**2005 IBHS Guidelines for Hurricane Resistant Residential Construction**

*Errata to the 1<sup>st</sup> Printing*

*April 2007*

FIGURE 305S1  
 PANEL ATTACHMENT FOR UPLIFT

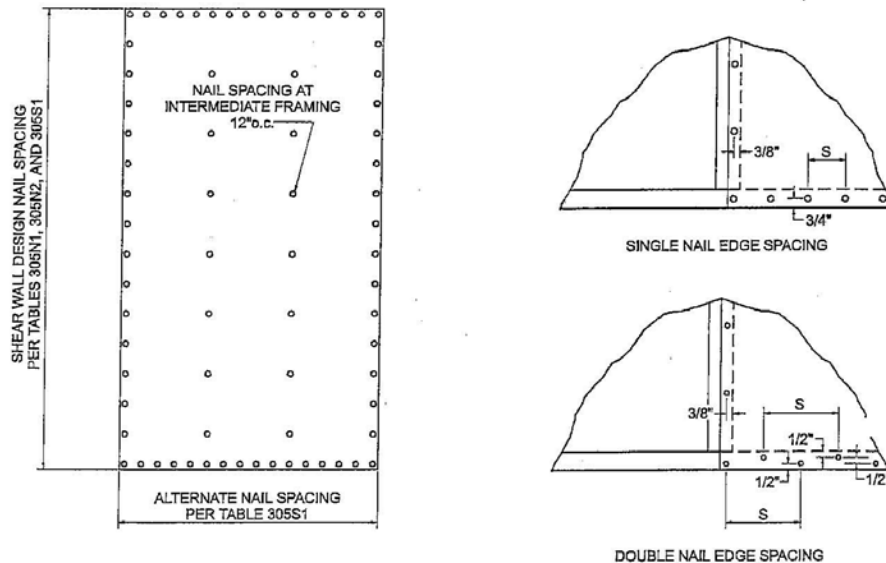
**Figure 305S1:** Replace Figure 305S1 with the following:

5. Panel attachment to framing shall be as illustrated in Figure 305S1.
6. Where windows and doors interrupt wood structural panel sheathing or siding, framing anchors or connectors shall be used to resist the appropriate uplift loads.
